PRODUCT UPDATE

#192

REDEL 1P Inline Receptacle PR_ New Design

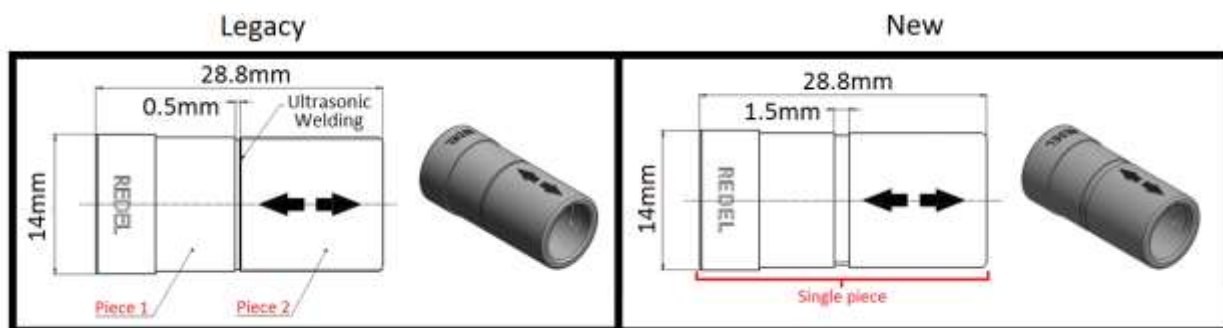
The design of the REDEL 1P inline receptacle PR_ model will be changing from a two-piece design to a single-piece design.

The PR_ model receptacle housing molds in the REDEL 1P Series have been updated, eliminating the need for ultrasonically joining two separate pieces. The 0.5mm ultrasonic weld band width is replaced with a 1.5mm band width, otherwise all other dimensions remain the same.

The part number of the parent level item remains the same.

All legacy internal components are compatible with the new single piece version.
